### **Amendment to the Drawings**

"Isolation of I2C Buses in a Multiple Power Domain Environment Using Switches"

Inventor: William J. Price  
Docket No.: 3PD-M-8504 US  
Replacement sheet 1/11

FIG. 1

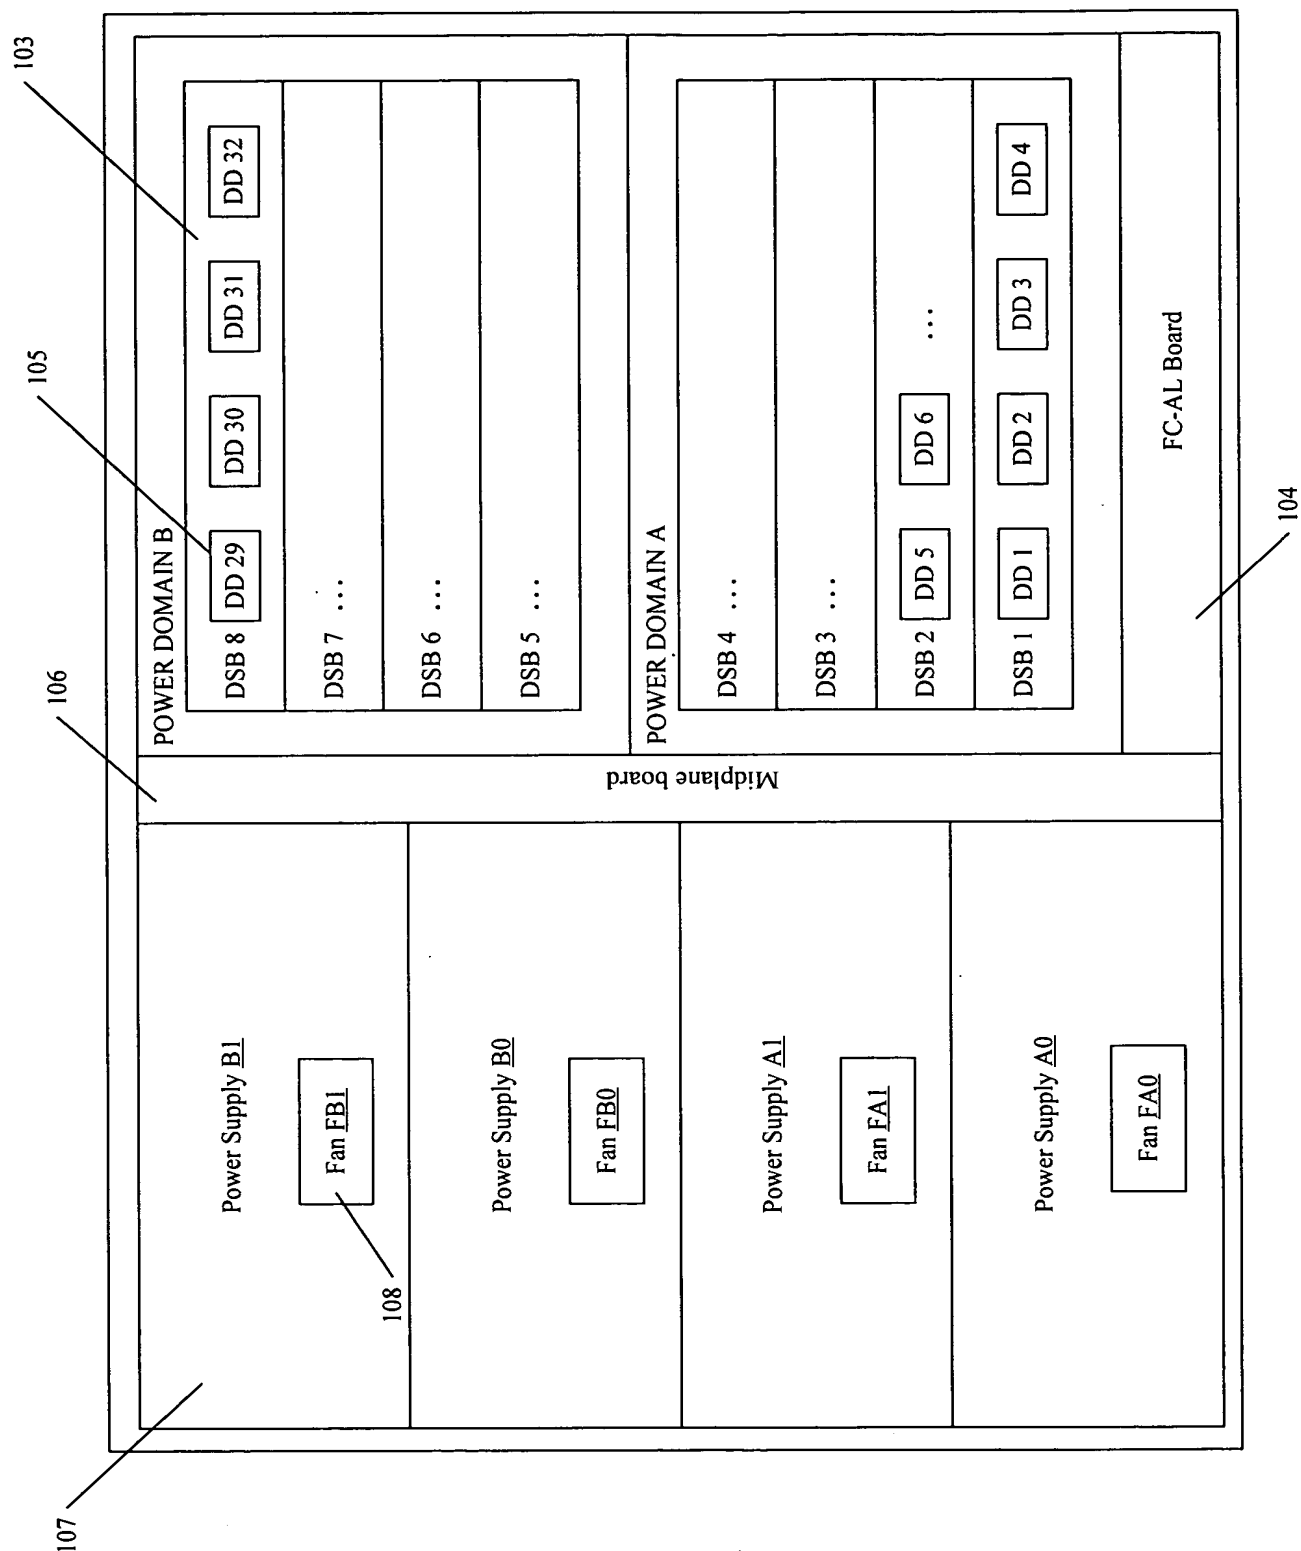
In Fig. 1, "Fan FB1" in power supply B0 has been changed to --Fan FB0--, "Fan FB1" in power supply A1 has been changed to --Fan FA1--, and "Fan FB1" in power supply A0 has been changed to --an FA0--.

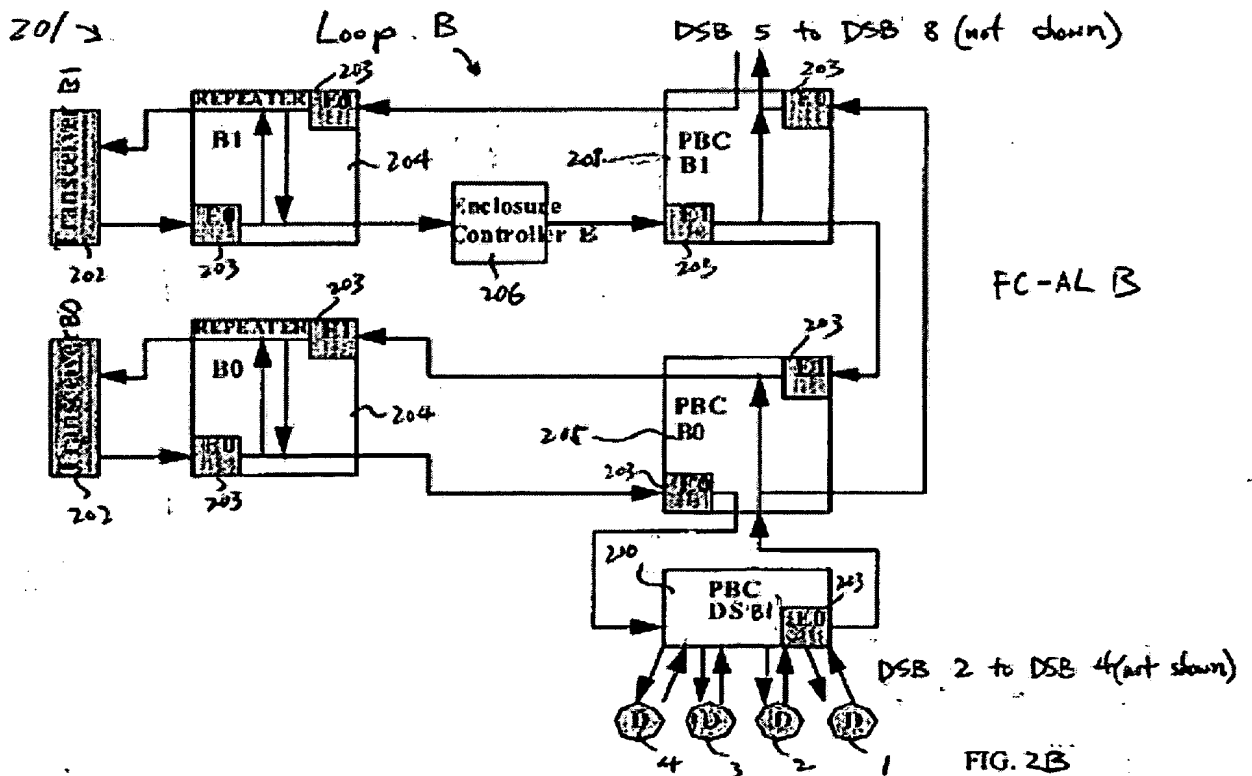
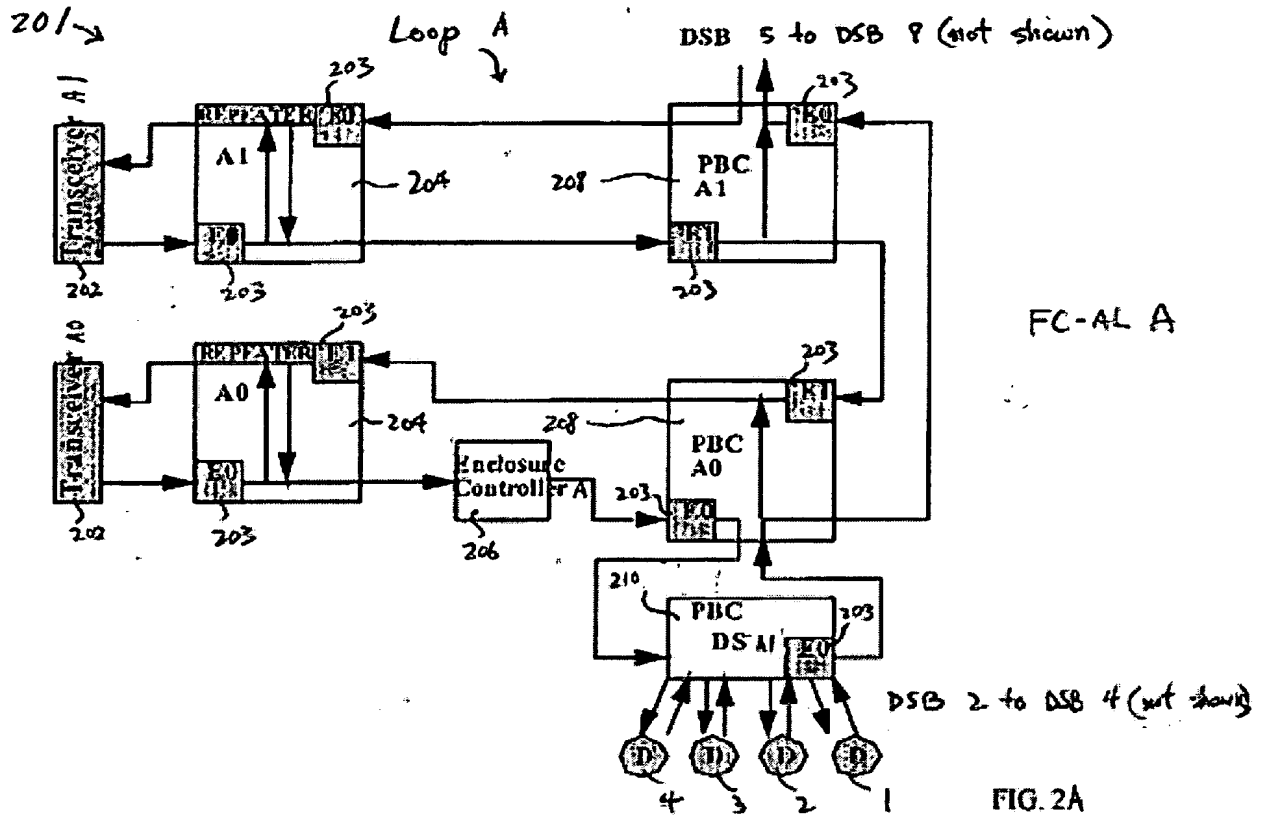
In Figs. 2A and 2B, reference numeral 201 has been added.

FIG. 4A

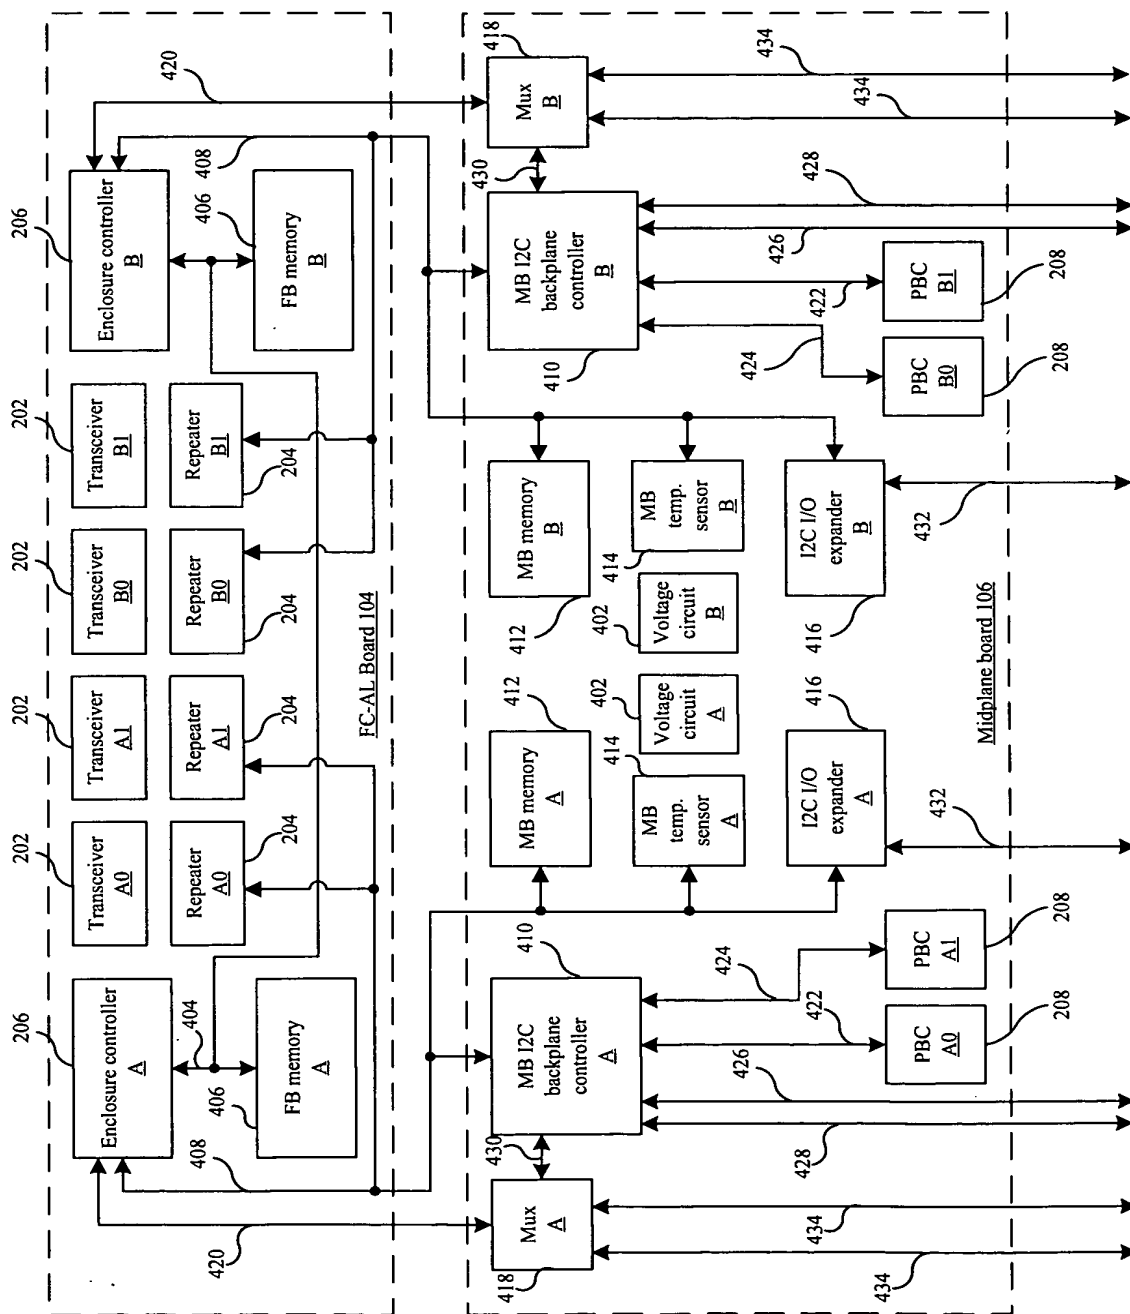
In Fig. 4A, reference numeral 404 has been added.

FIG. 7A

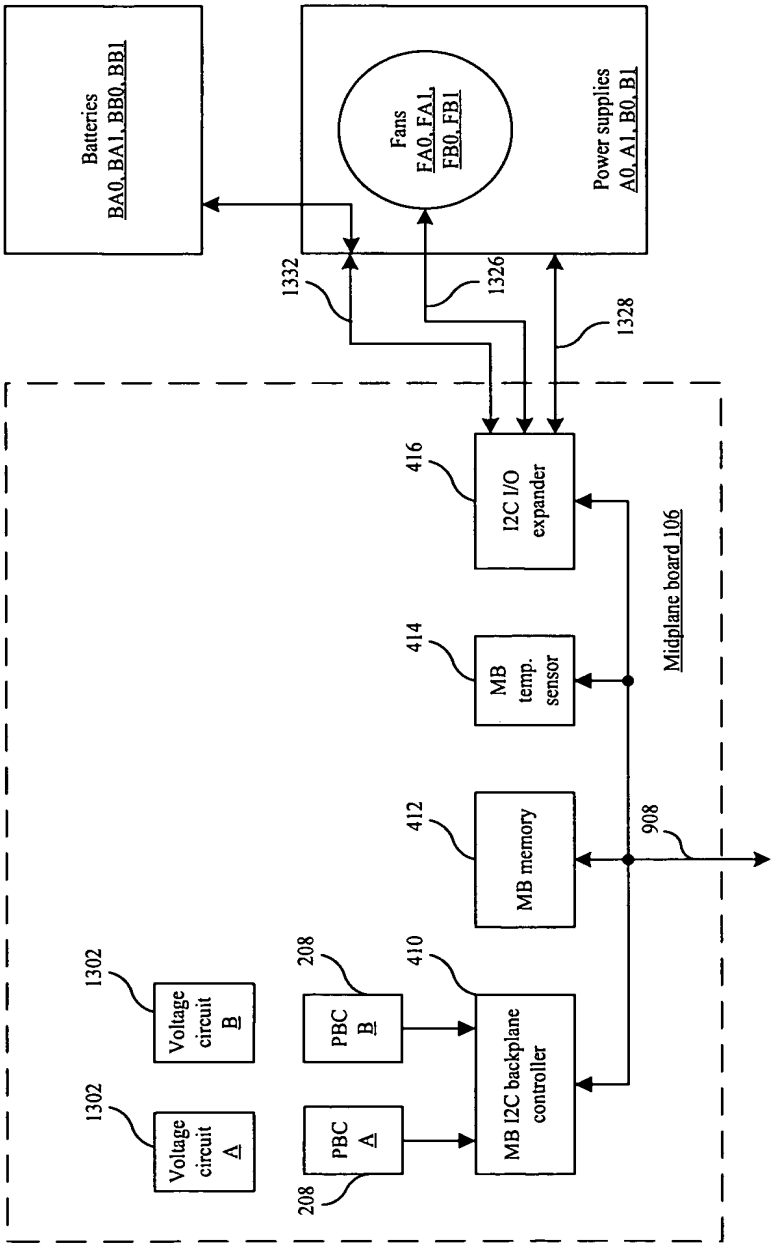
In Fig. 7A, reference numeral "Midplane board 106" has been added.

FIG. 7B

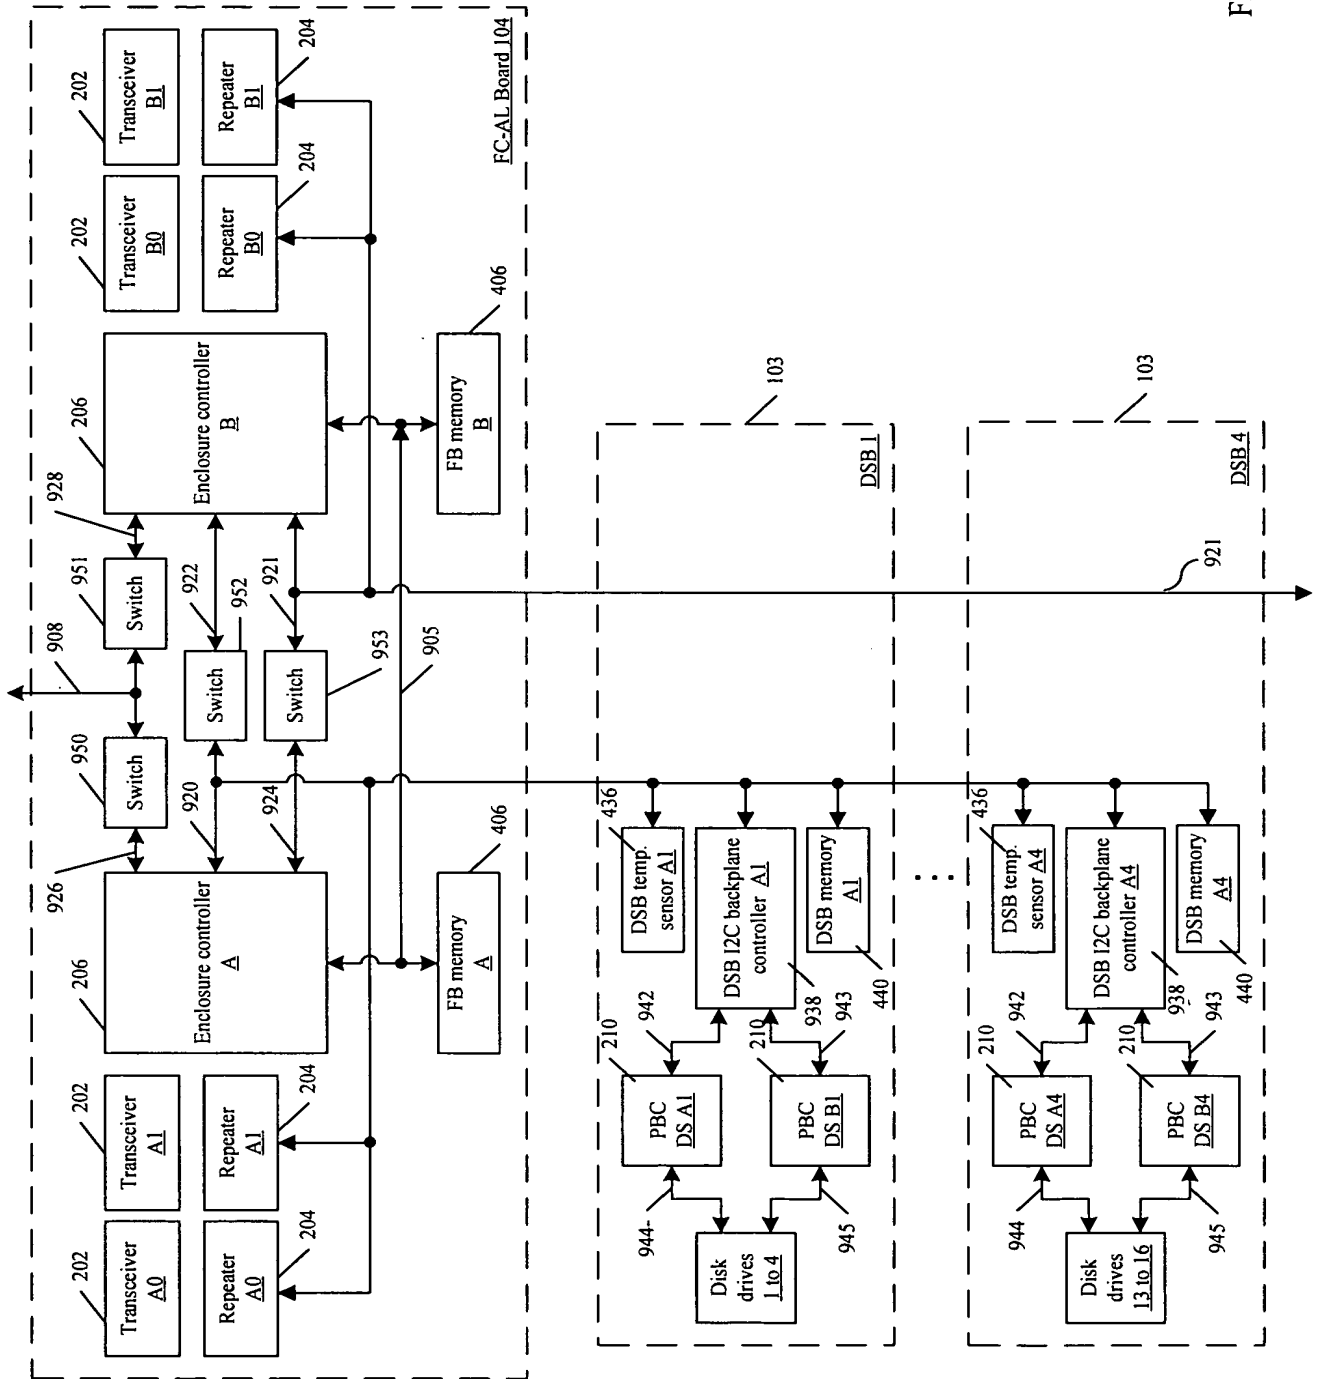
In Fig. 7B, reference numeral "Disk drives 1 to 3" has been changed to --Disk drives 1 to 4--.
